PRODUCT SUPPORT BULLETIN NO. 211

MACHINE: **Auto-Lift S/N 200 through 543 Numbers**

SUBJECT: PROPEL MOTOR CHAIN ADJUSTMENT & MOTOR MOUNTING

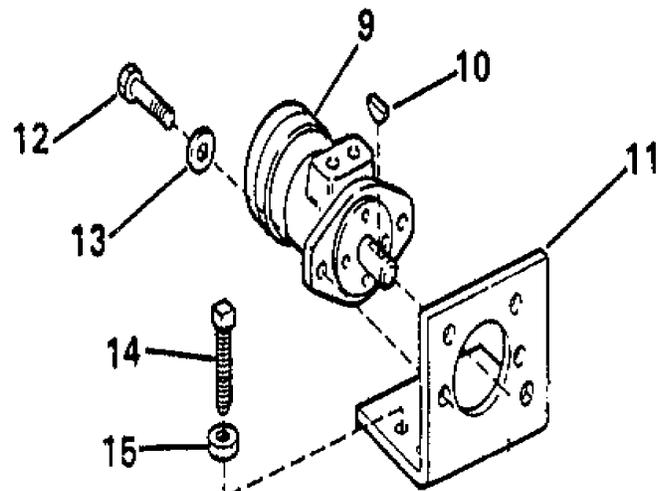
It was difficult to adjust the propel motor chain slack and change out the motor because of the placement and type of bolts used in this application.

To remedy this problem, the following changes have been made:

1. The 2145 0044 Propulsion Motor Mounting (Item #11 in illustration) has been made 1/2-inch longer to increase wrench clearance.
2. The 2947 193 Square Head Setscrew 1/2-13 x 2 (Item #14) has been replaced by a 2775 321 Hex Head Capscrew 1/2-13 x 2.
3. The 2775 292 Hex Head Capscrew 1/2-13 x 1-1/4 (Item #12) has been replaced by 2783 291 Socket Head Capscrew 1/2-13 x 1-1/4.
